**66104A-09**

**S E R V I C E N O T E**

**66104A DC Power Supply**

**The instrument will not communicate or will not complete self test.**

**Figure1**

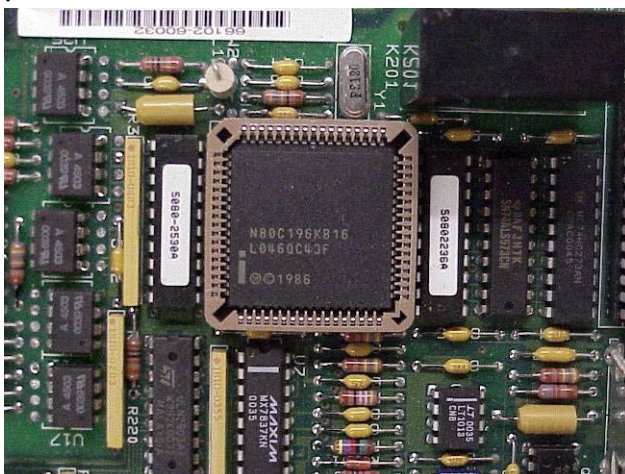
Figure 1 will help to identify the **68-PIN PLCC SOCKET location** - P/N 1200-1274 (Circuit Reference “U001”)

**Figure 2**

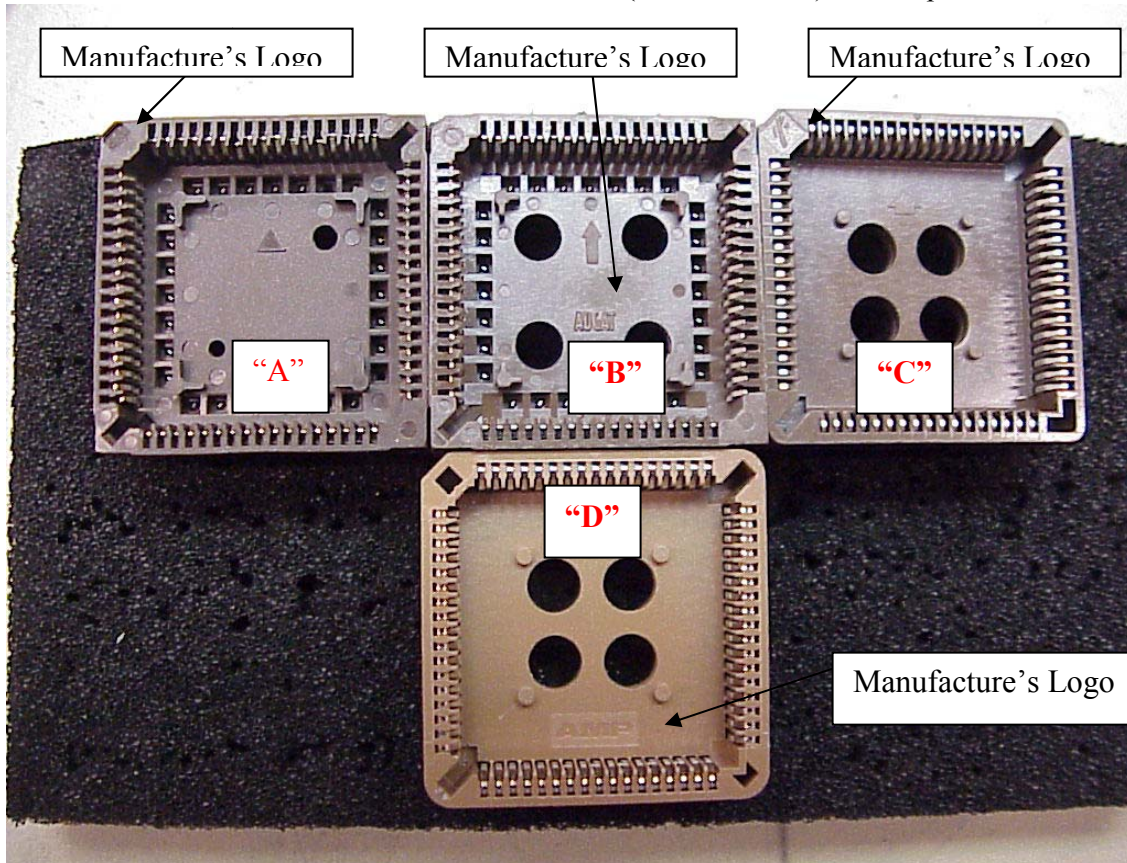
This figure should be used to identify **GOOD** sockets and a potential defective socket. The **16-Bit MCU 16 MHZ 68PLCC CMOS IC** (P/N 1821-1479) is **NOT** pictured.

The following information will help identify each socket type and manufacturer. The manufacturer's logo can be identified as shown. After the **16-Bit MCU 16 MHZ 68PLCC CMOS IC** has been removed there are also mold markings that can be easily viewed these markings should be used to identify a **Good or Defective socket**.

- Socket **"A"** is a sample of a GOOD AMP socket.
- Socket **"B"** is a sample of a GOOD Tyco/Augit socket.
- Socket **"C"** is a sample of a GOOD FCI socket.
- Socket **"D"** is a sample of a DEFECTIVE Tyco socket.

The sockets above labeled **"A", "B" or "C"** are good and should NOT be replaced. The socket above labeled **"D"** is considered defective should be replaced.

## Discipline “A” &amp; “B”

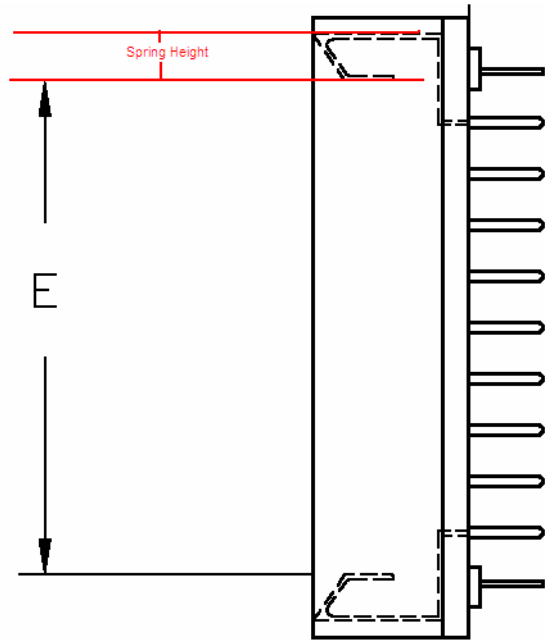
**Discipline A – Permanent Corrective Action Plan “The socket shown in the pictures are for reference ONLY”**

The condition of the recessed beams has been corrected by a design enhancement implemented in production. This design enhancement increased the spring height dimension by 0.04mm and decreased the spring height tolerance by 40%. The spring height dimension is shown in the drawing below.

This design enhancement is intended to position the contact beams closer to the middle of the socket and increase the normal force exerted on the contacts of the chips mated to the socket.

**Discipline B – Verification of Corrective Action “The socket shown in the pictures are for reference ONLY”**

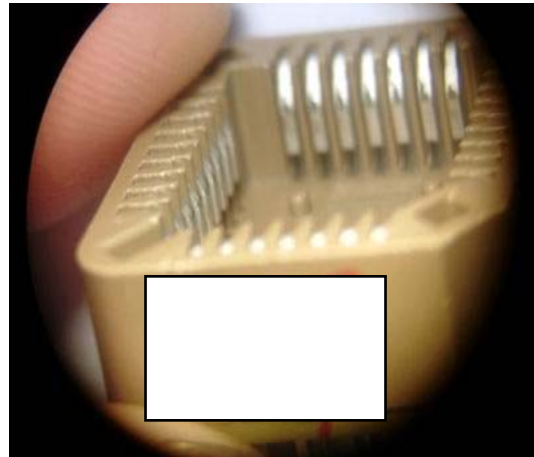
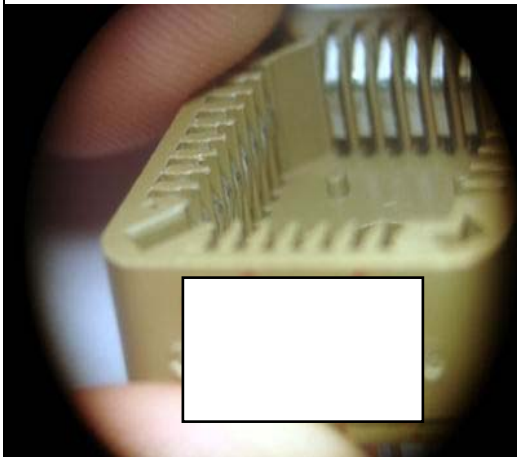
The effectiveness of this design enhancement was tested by comparing the mating and un-mating forces on the older and newer designs. The test results for sockets with the increased spring height (newer design) showed an increase in the mean mating force of 18.9% and an increase in the mean un-mating force of 23.4%. The increase in the un-mating force test results between the old design and the new design indicate that a greater normal force is being exerted on the test chip contacts by the socket contact beams. The two revisions of this contact beam design were visually examined after the mating and un-mating force testing. Photos of the two sockets are shown below. The photo on the left shows the older version socket prior to the enhanced contact beam design. The photo on the right shows a socket with the design enhancement. The contacts with the older design appear to be recessed farther into the housing after un-mating.

Material with this design enhancement will be labeled with a 2007 date code
